TOWN OF BLUFFTON

STAFF REPORT Department of Growth Management

MEETING DATE:	June 22, 2016
PROJECT:	Cypress Ridge Commercial Building, RV and Boat Storage and Phase 7 Buffer Certificate of Appropriateness Highway Corridor Overlay
PROJECT MANAGER:	Erin Schumacher, AICP Senior Planner

1. **COFA-06-16-9716.** A Certificate of Appropriateness to permit the construction a commercial office of approximately 4,490 SF, RV and boat storage, and the Phase 7 Buffer along with the associated lighting and landscaping improvements. The property is located at the intersection of Highway 170 and Hulston Landing Road within the Cypress Ridge Development, zoned PUD, and lies within the Cyprus Ridge/Jones Estate PUD.

WALL SECTIONS

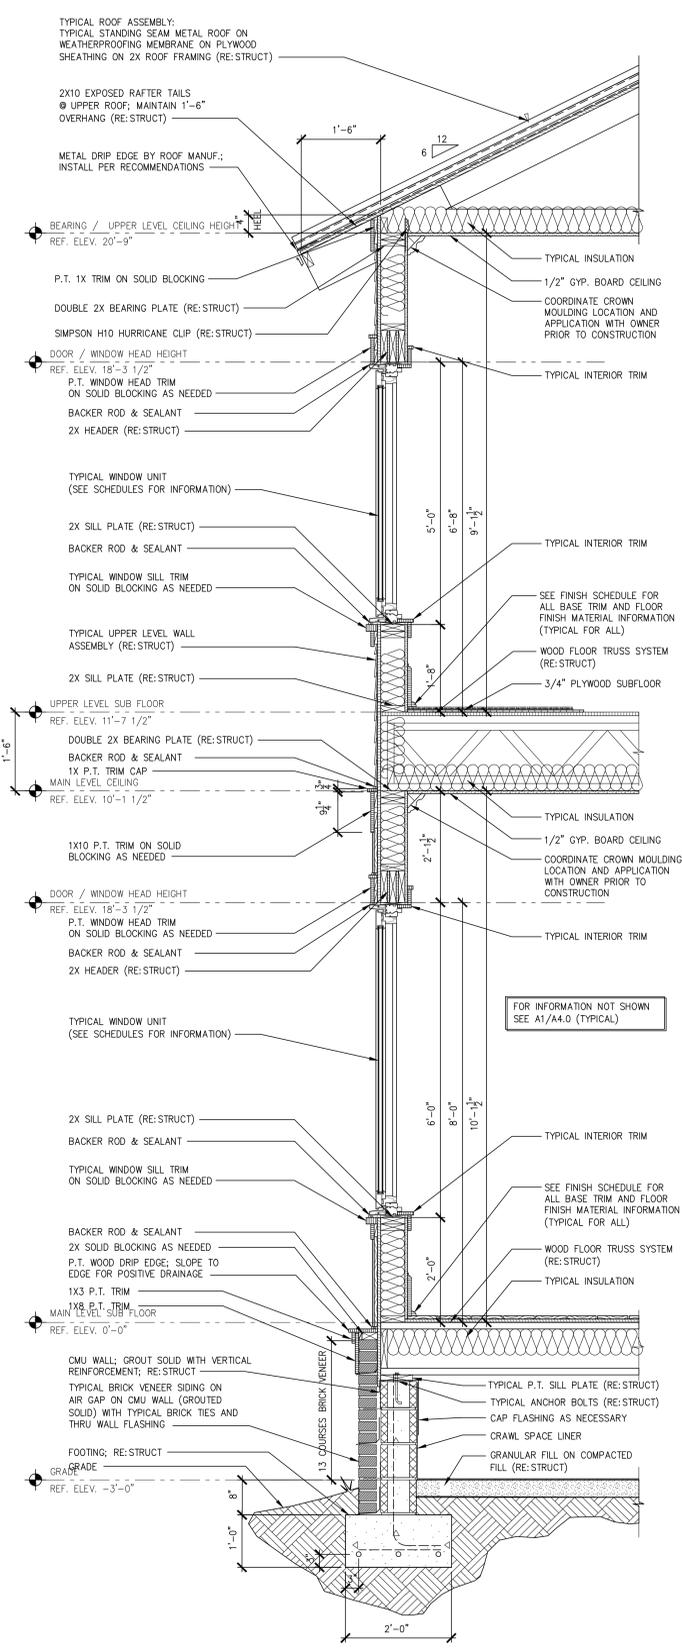
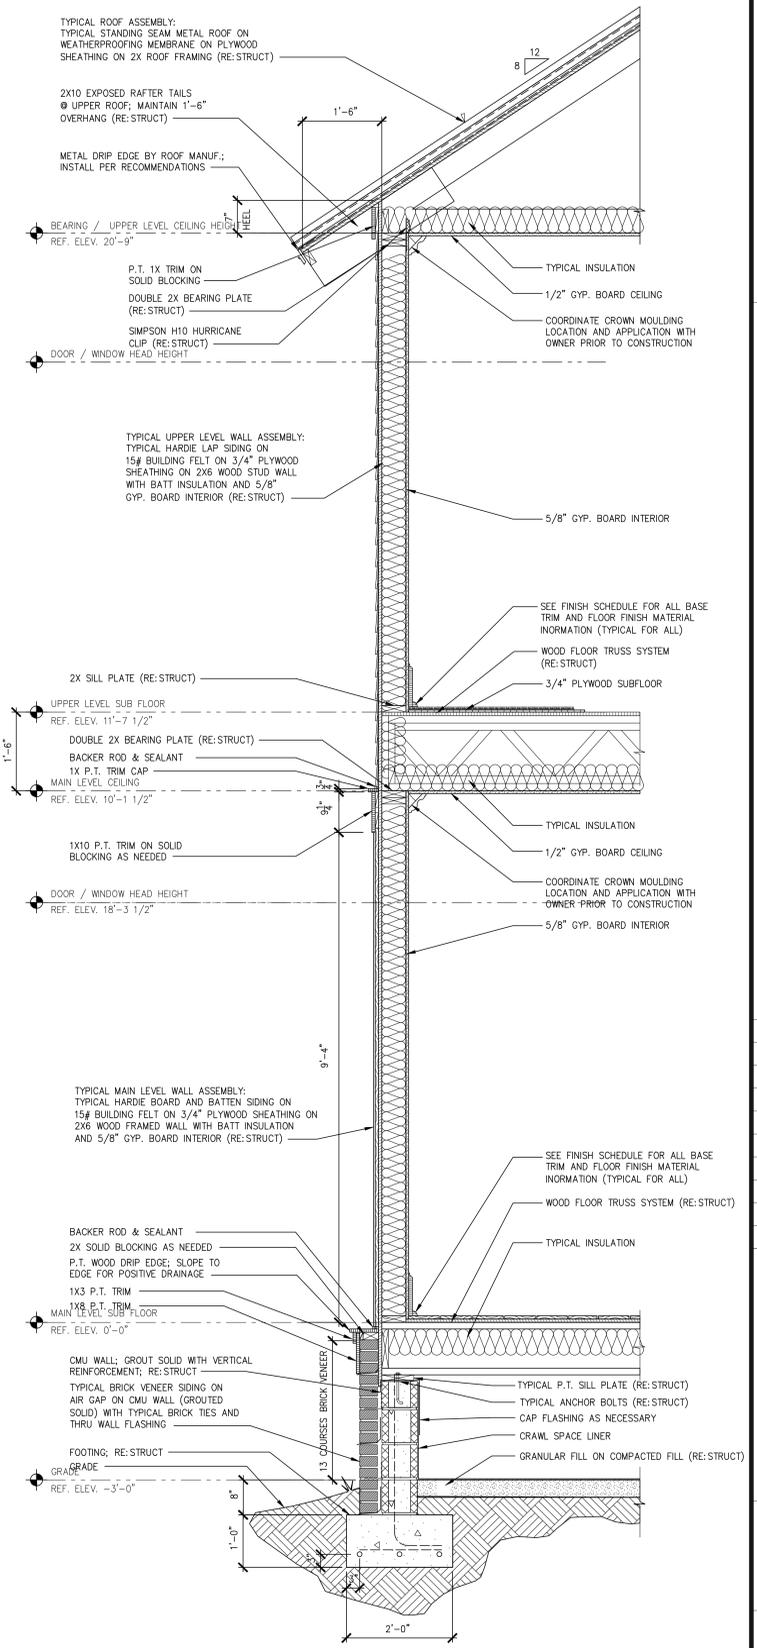
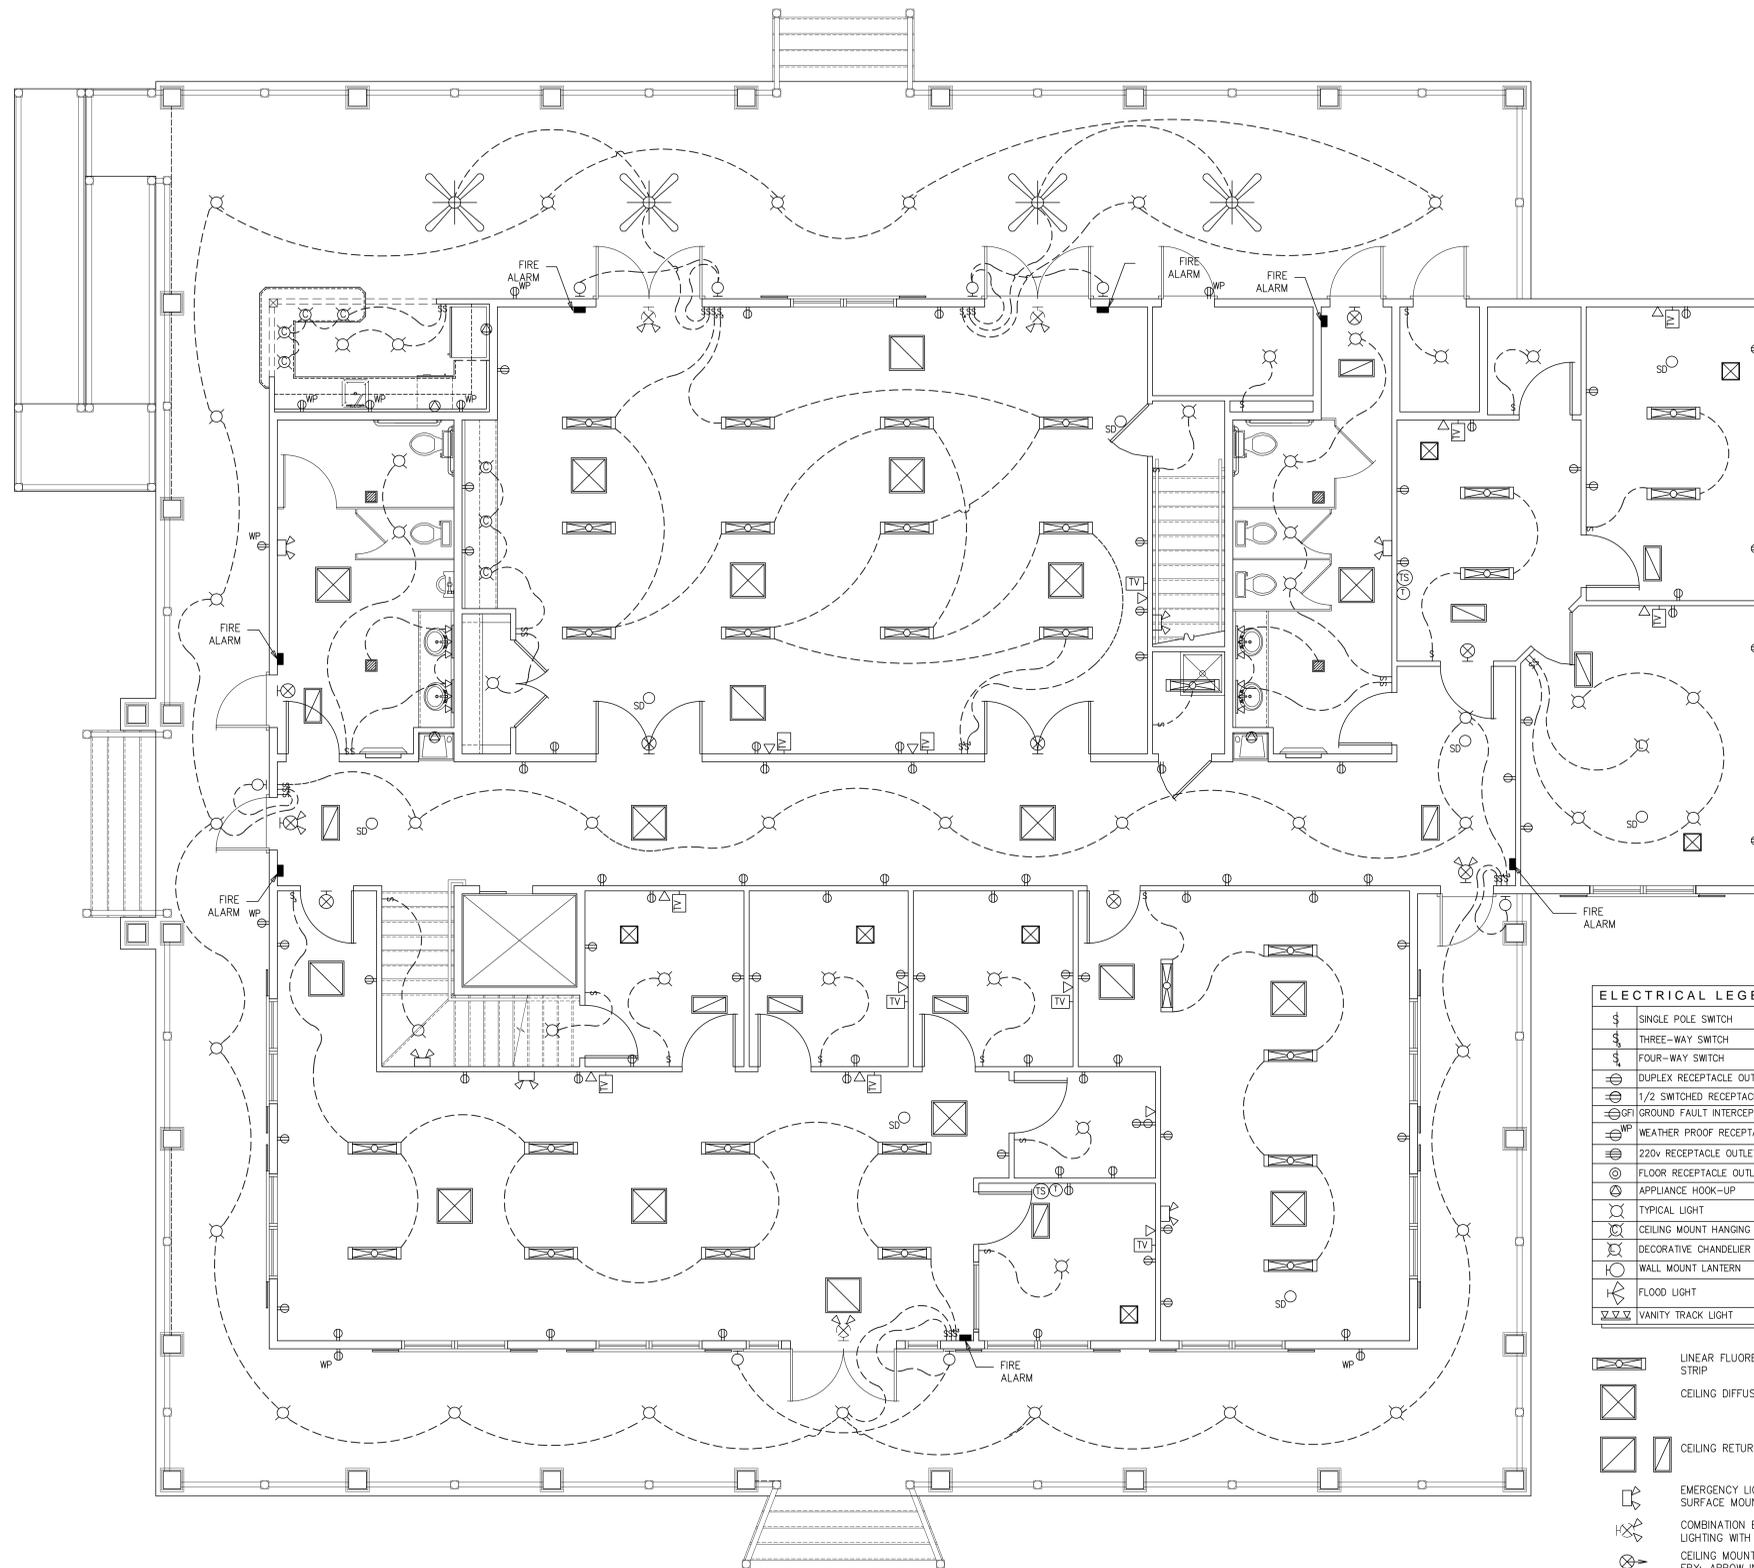
- 2) Finding – Inappropriate Exterior Materials and Architectural Elements. Section 4.24.3.A.3. of the ZDSO notes that cinder block and unfaced concrete block are considered incompatible and inappropriate for primary structures. The architectural renderings and elevations appear to have concrete block at the foundation while the building section notes brick over the concrete block. It is unclear the intent. The drawings must be revised for consistency and to utilize appropriate exterior materials.

- b. Per Section 4.24.3.A.3. of the ZDSO, the foundation material must be revised to an appropriate material and the associated drawings updated to reflect the materials.
